# RENESAS TECHNICAL UPDATE

Product Category	MPU/MCU	Document No.	TN-RL*-A052A/E	Rev.	1.00
Title	Precaution of using High accuracy 1 Hz output		Information Category	Technical Notification	
Applicable Product	RL78/I1B Group R5F10Mxx	Lot No.	Reference Document	RL78/I1B User's Manual: Hardware Rev2.00 R01UH0407EJ0200(Mar 2014)	
		All lot

List of corrections to be added in this notification

1-1. Precaution regarding the clock error correction register (SUBCUD) setting procedure when using the high accuracy 1 Hz output.

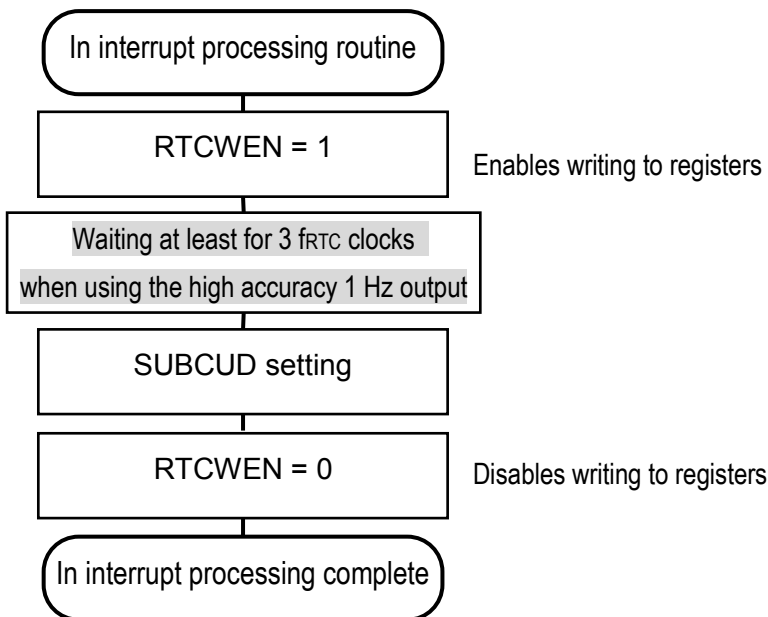
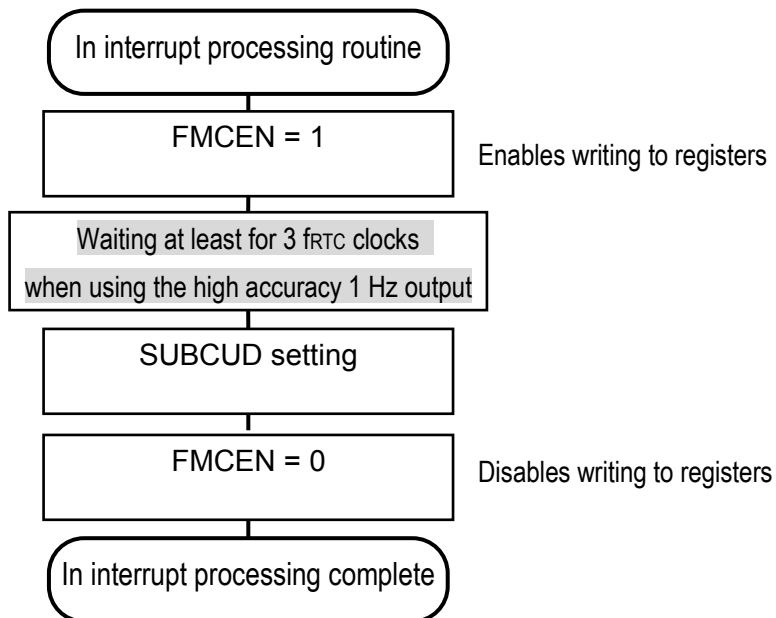
RTC correction may not be successful if there is a conflict between the SUBCUD register rewrite and correction timing. In order to prevent conflict between the correction timing and rewrite of the SUBCUD register, be sure to complete rewrite of the SUBCUD register before the next correction timing occurs (within approx. 0.5 seconds), which is calculated starting from the correction timing interrupt (INTRTIT) or periodic interrupt (INTRTC) that is synchronized with the correction timing.

**When using the high accuracy 1 Hz output and rewriting the SUBCUD register, rewrite the SUBCUD register after waiting at least for 3 fRTC clocks.**

(1) Set the clock error correction register (SUBCUD) after setting RTCWEN to 1 first. Then set RTCWEN to 0 after completion of the register setting.

(2) Set the clock error correction register (SUBCUD) after setting FMCEN to 1 first. Then set FMCEN to 0 after completion of the register setting.

Figure 8-1. Real-time Clock 2 Diagram

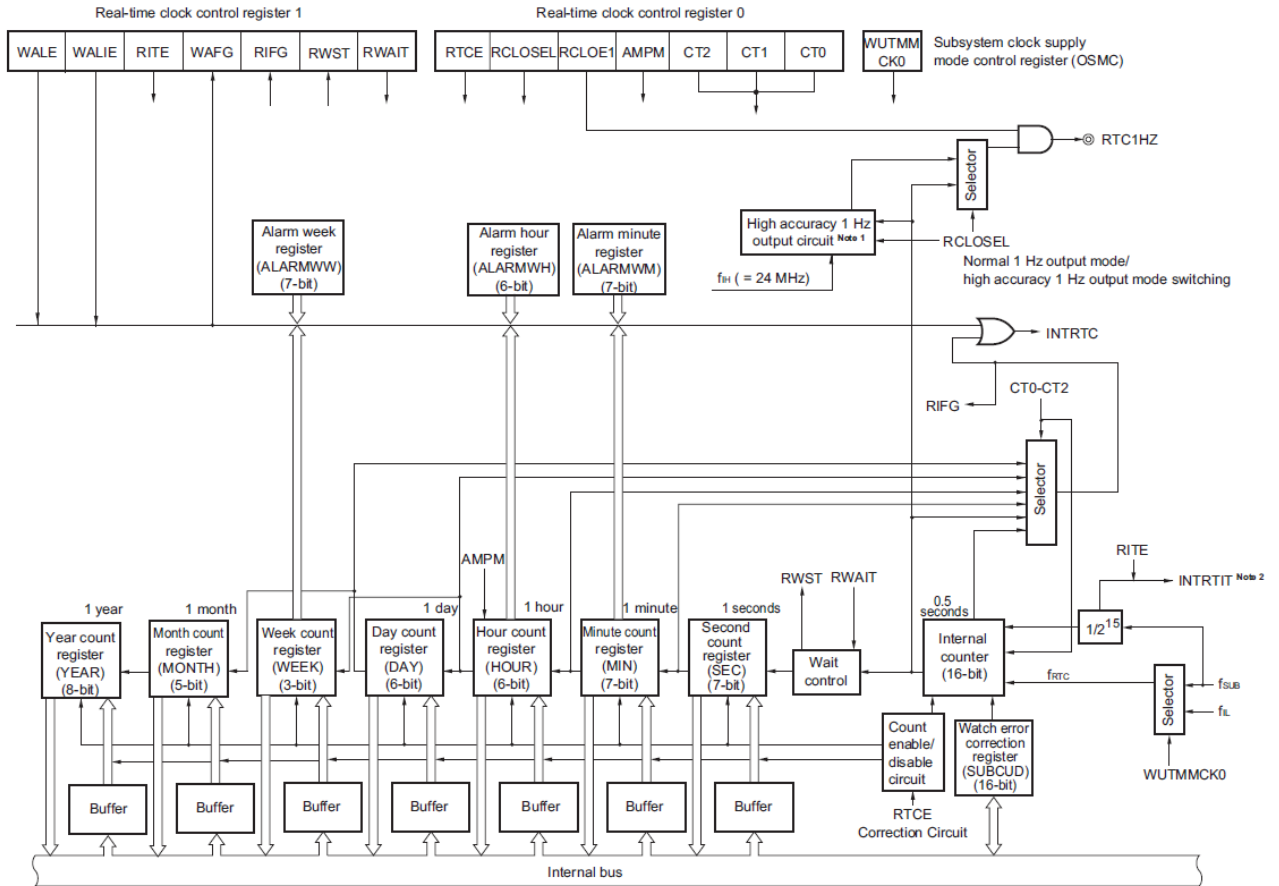
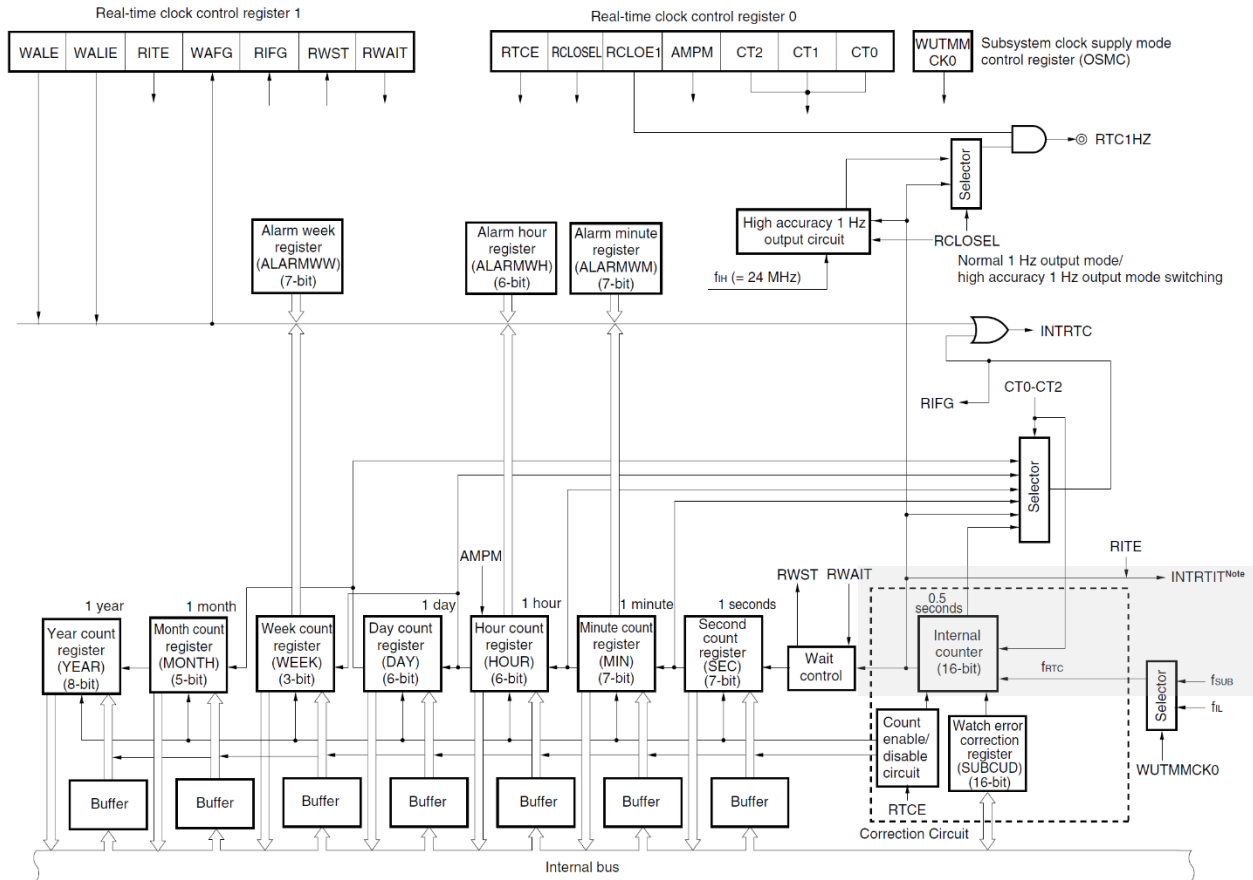
1-2. Root correction of the INTRTIT in the Real-time Clock 2 Diagram

**Note** An interrupt that indicates the timing to get the correction value from the clock error correction register (SUBCUD). The fetch timing is 1 second ( $f_{SUB}$  base) interval.
